CONSTRUCTION PLANS FOR PMG PARADISE CLINIC PUBLIC INFRASTRUCTURE ALBUQUERQUE, NEW MEXICO

RECORD DRAWINGS

CITY OF ALBUQUERQUE	
		DEPARTMENT OF MUNICIPAL DEVELOPMENT	
PMG PARADISE CLINIC PUBLIC INFRASTRUCTURE			
PARADISE BLVD OVERALL PAVING PLAN			
DESIGN REVIEW COMMITTEE	CITY ENGINEER APPROVAL	NO. / DAY / YR.	NO. / DAY / YR.

SHEET NO.

C-200

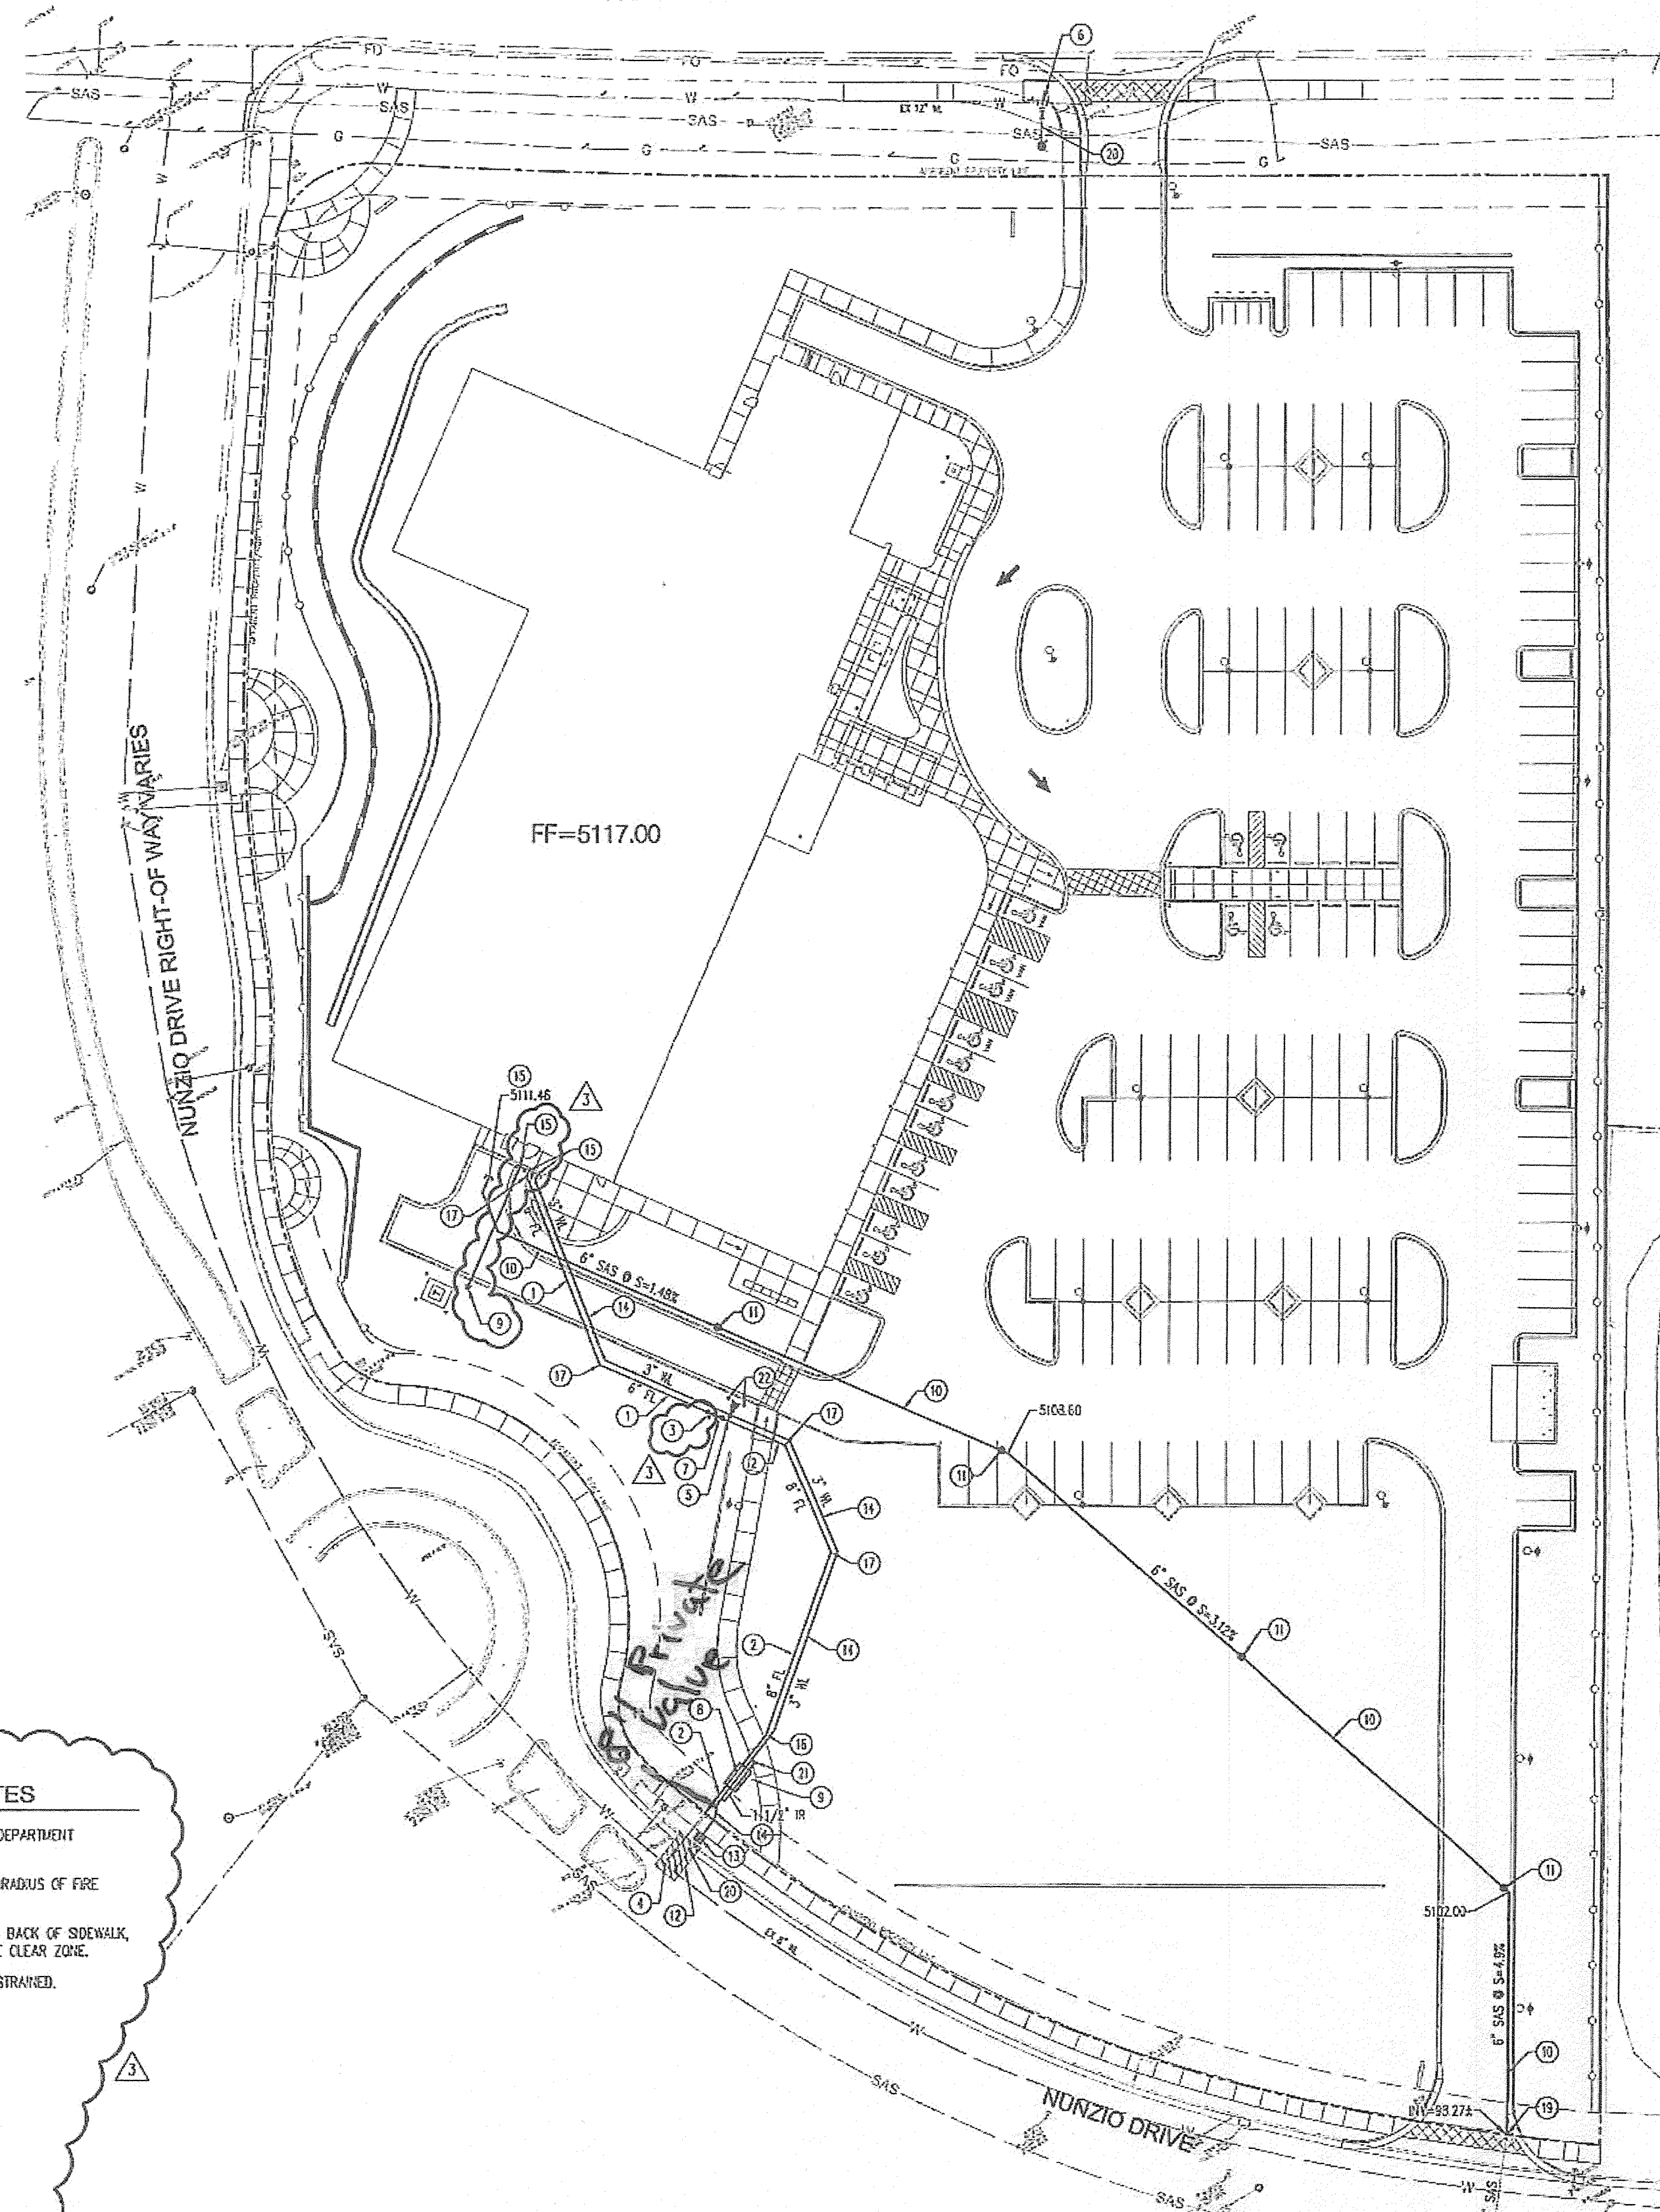
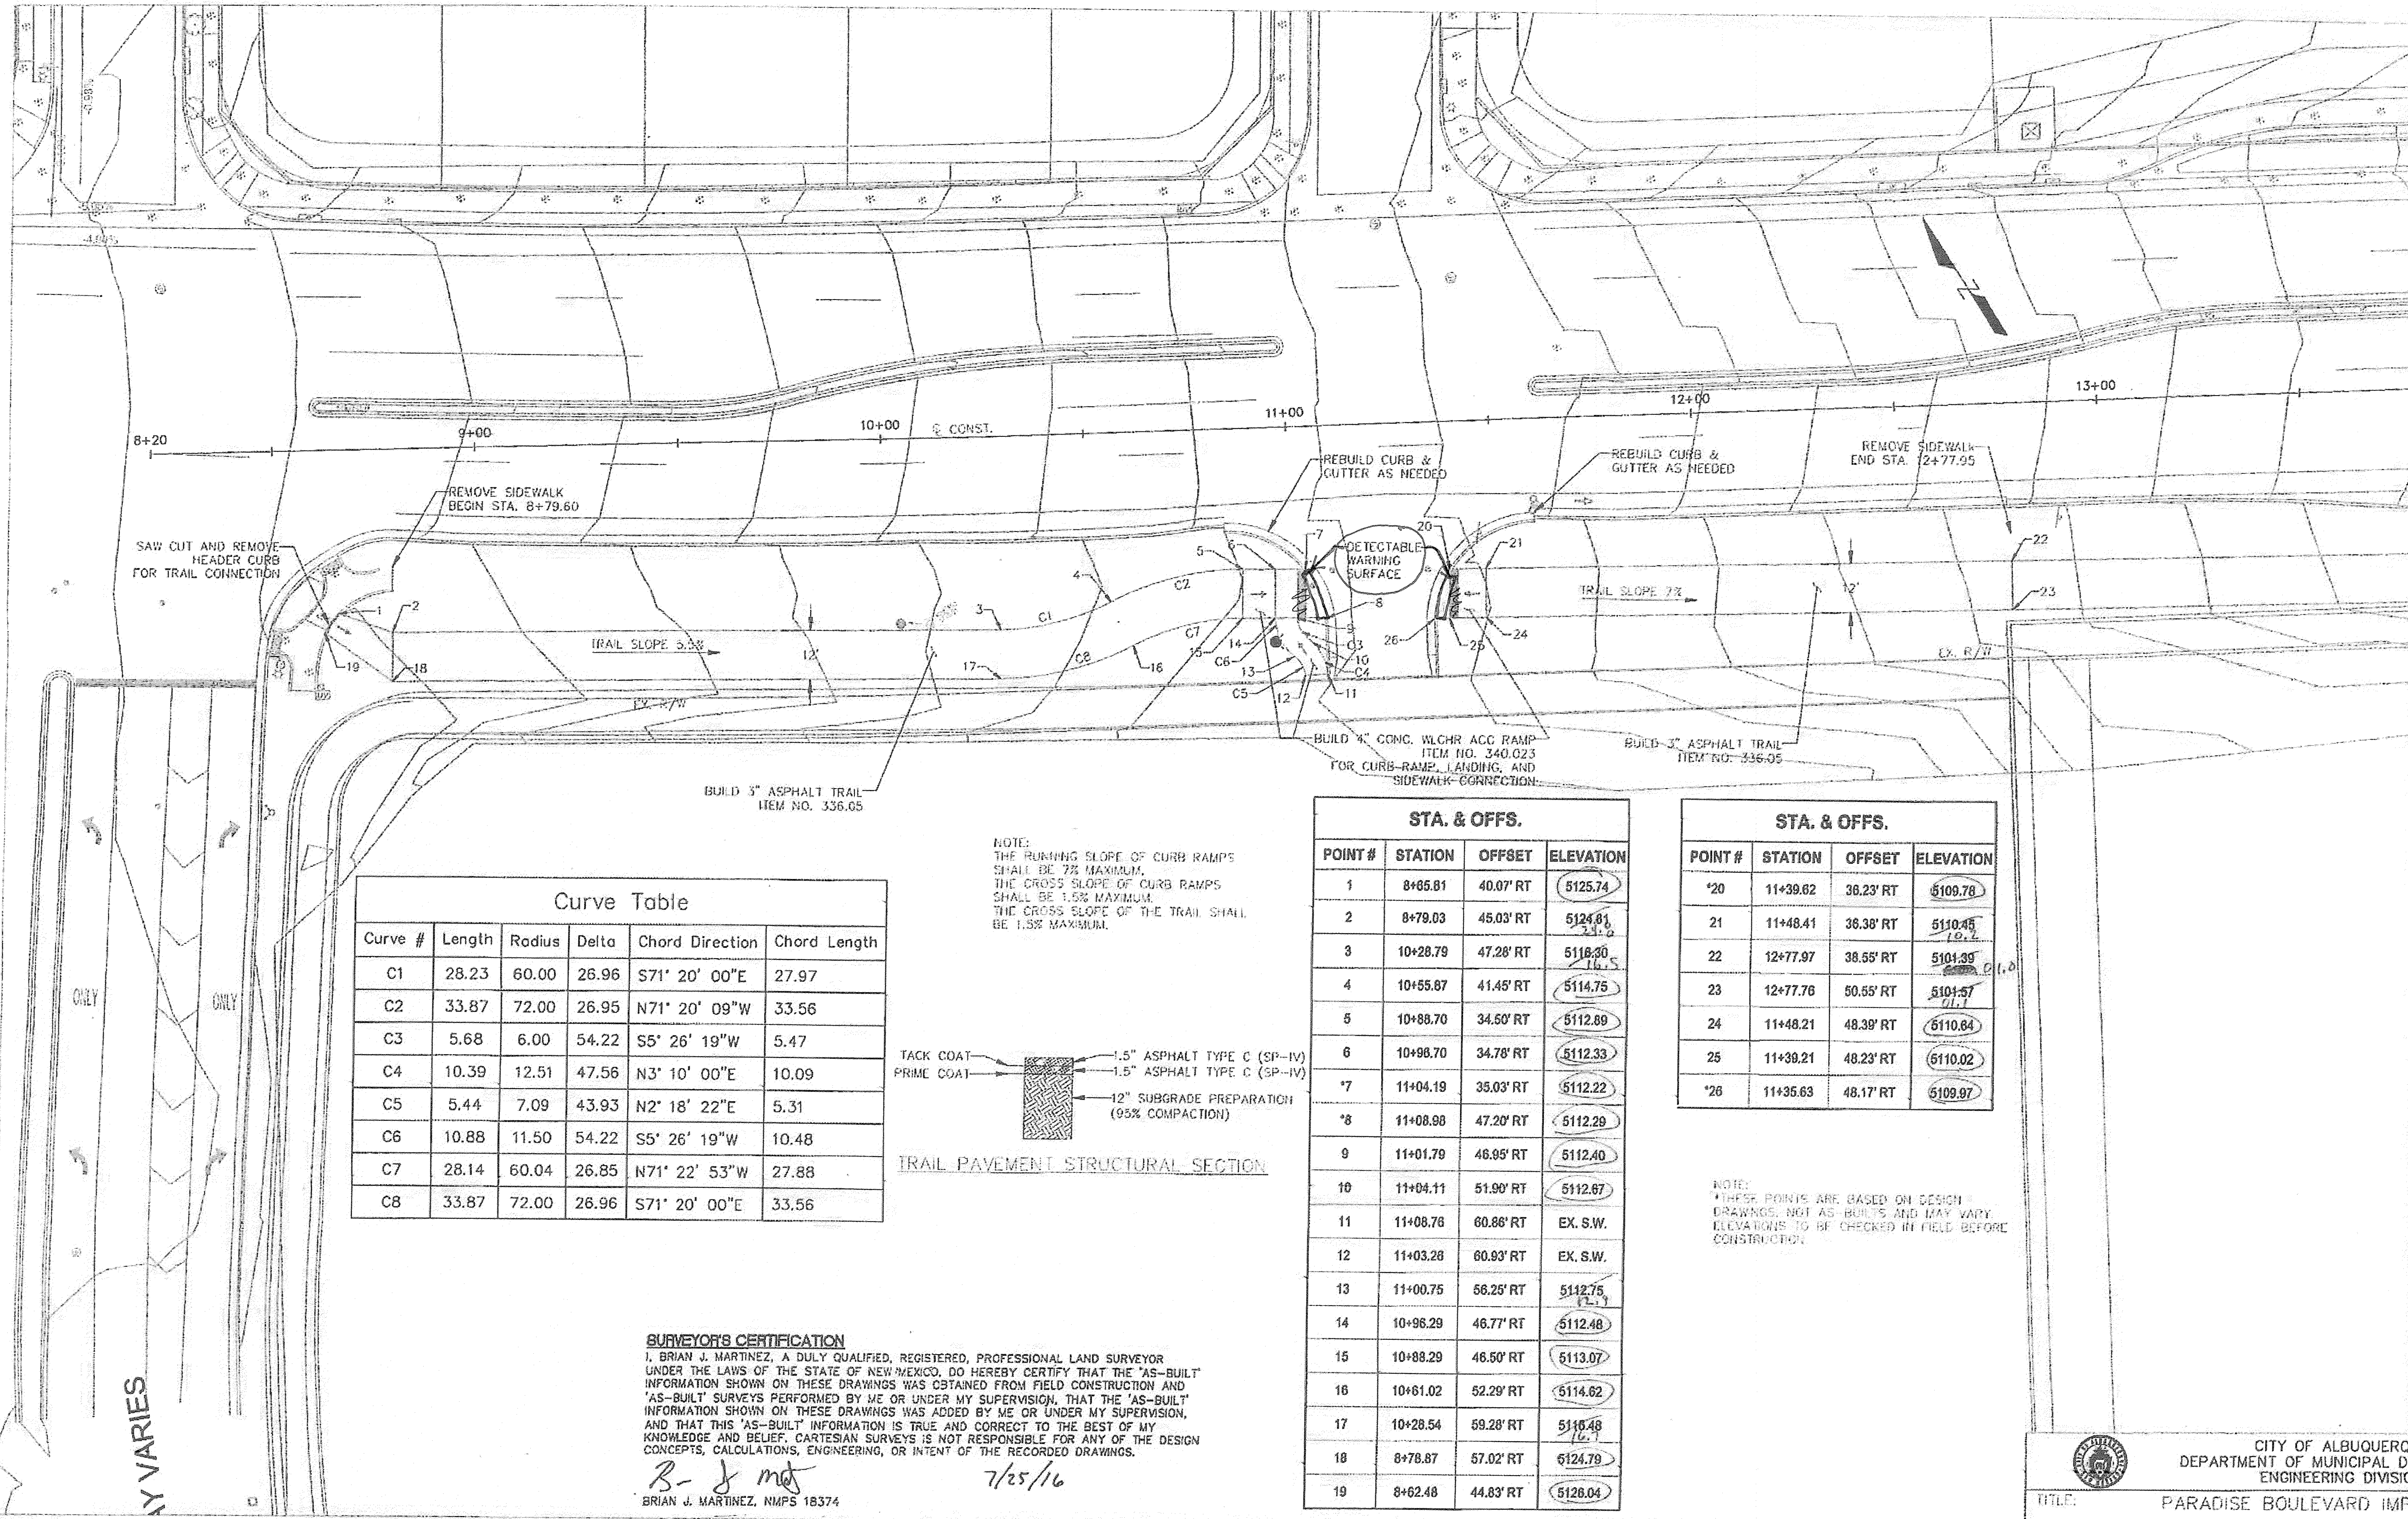
ADD WALL FDC

RELOCATE P.I.V. DOWNSTREAM
FROM PRIVATE HYDRANT OR
ADD WALL P.I.V.

ELIMINATE 8" GATE VALVE/PIV

ELIMINATE REMOTE FDC
